Errata 001 (03/2004)

Funcionality of PCMCIA ports

(only for BaseBoard full - 5302 and Development kit - 5400, PCB version 2.1):

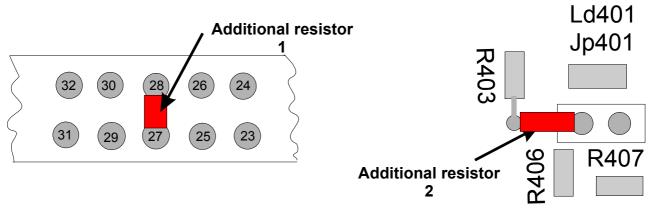
Problem: May ocuure crashing the system until linux is starting

Solution: Signal P4_WAIT must be PULL UP

You need add 2 resistors 4k7

- between pin 27 and pin 28 of IDE connector (J402) bottom side of PCB
- between HDD LED jumper Jp401 pin 2 and via nearest this pin top side of PCB

Programming of Cygnal C8051F303 controller

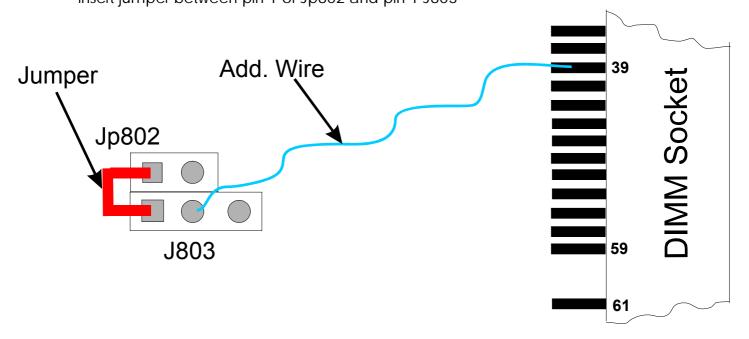
Problem: Controller Cygnal is not detected in Armboot (reprogramming is not possible)

Solution: Signal C2D must be connected to SSP_TXD (not SSP_RXD)

- you need make additional connection between pin 39 of DIMM socket and pin 2 of J803
- insert jumper between pin 1 of Jp802 and pin 1 J803
